Federal Highway
Administration

Refer to: HNG-14

Supplement to Geometric and Roadside Design Acceptance Letter CC-35 (CC-35A)

Supplement to Geometric and Safety Design Group Acceptance Letter CC-35 (CC-358)

Figure 1. Anchoring Details - QuadGuard™ CZ Test 159-058

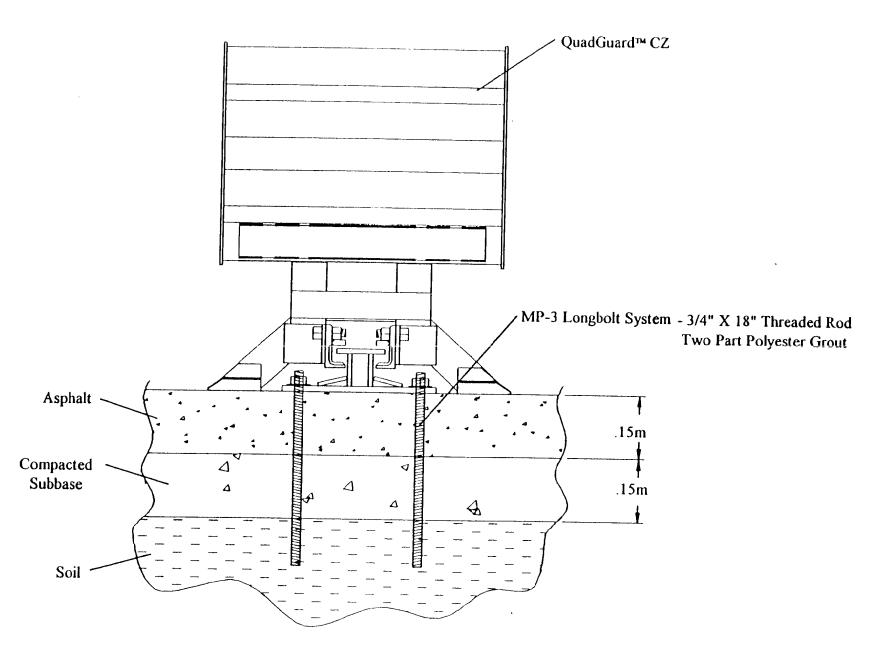
In your June 24 letter to Mr. Gerald L. Eller, you requested the Federal Highway Administration's (FHWA) acceptance of the QuadGuard CZ for use as a temporary crash cushion in work zones. You stated that the QuadGuard CZ is essentially identical to that used in a permanent installation except for its anchoring system. Based on an analysis of the full-scale crash tests conducted to certify the permanent QuadGuard as a National Cooperative Highway Research Program Report 350 TL-3 attenuator, you concluded that test 3-37 (2000-kg pickup truck at 100 km/h impacting at 20 degrees at the beginning of the attenuator length of need) would be the most severe test of the anchoring system. test 3-37 was successfully run and reported in "Quad Guard CZ Anchoring Test" prepared by Mr. John V. Machado and dated June 17, Revision A. The specific anchoring system used was the "MP-3 Longbolt System," which uses a two-part polyester grout to anchor 20-mm diameter x 460-mm long threaded rods to a foundation of 150-mm deep asphalt over a 150-mm deep compacted subbase. rods are to be embedded to a minumum depth of 410 mm in 22-mm diameter drilled holes. A total of 50 anchors are needed. anchor system is shown in Figure 1 and the summary test results are shown in Figure 2.

Based on the test results, we conclude that the QuadGuard CZ qualifies as a TL-3 attenuator when anchored as tested. When used in a location subject to reverse-direction impacts, a crashtested transition design should be used to prevent snagging on the back end of the QuadGuard unit. Subject to the foregoing, the QuadGuard CZ may be used on projects on the National Highway System (NHS) when requested by a State agency. Since the QuadGuard CZ is a proprietary device, its use on Federal-Aid
